Well Name: MARTINEZ BEGAY COM	Well Location: T24N / R10W / SEC 34 / SESW / 36.2654033 / -107.887423	County or Parish/State: SAN JUAN / NM
Well Number: 2	Type of Well: OTHER	Allottee or Tribe Name: EASTERN NAVAJO
Lease Number: NOG09021754	Unit or CA Name: 2 MARTINEZ BEGAY COM-S/2	Unit or CA Number: NMNM112624
US Well Number: 300453492300S1	Operator: DUGAN PRODUCTION CORPORATION

Notice of Intent

Type of Submission: Notice of Intent	Type of Action: Plug and Abandonment
Date Sundry Submitted: 11/17/2025	Time Sundry Submitted: 08:04
Date proposed operation will begin: 11/19/2025

Notice of Intent – Plug and Abandonment

Planned P & A Wellbore Schematic

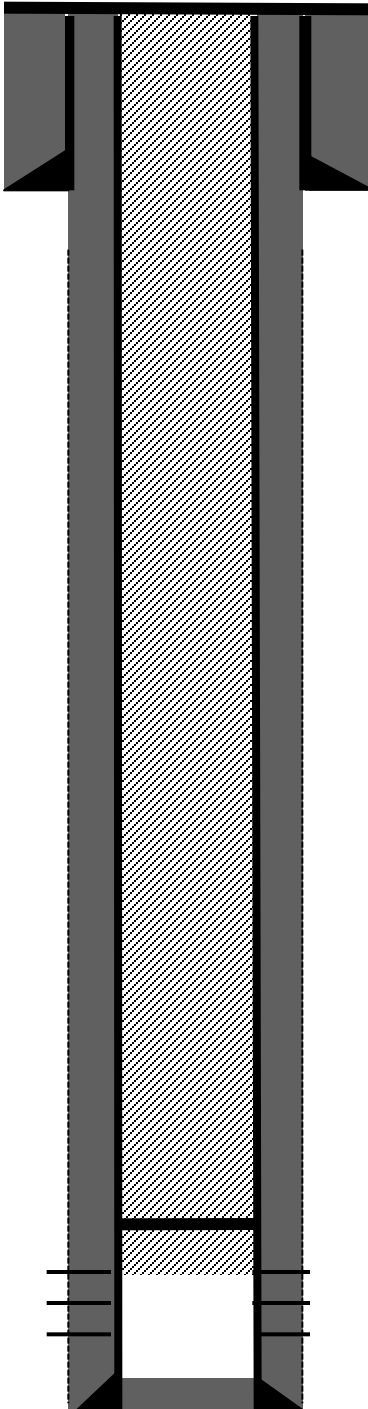
1. Plugging operations authorized are subject to the attached "General Requirements for Permanent Abandonment of Wells on Federal and Indian Lease."
2. The following modifications to your plugging program are to be made:
 - a. Complete wellbore fill up proposal. No changes to the procedure.
3. **Notification:** Farmington Office is to be notified at least 24 hours before the plugging operations commence at (505) 564 7750.

Complete wellbore fill up proposal. No changes to the procedure.
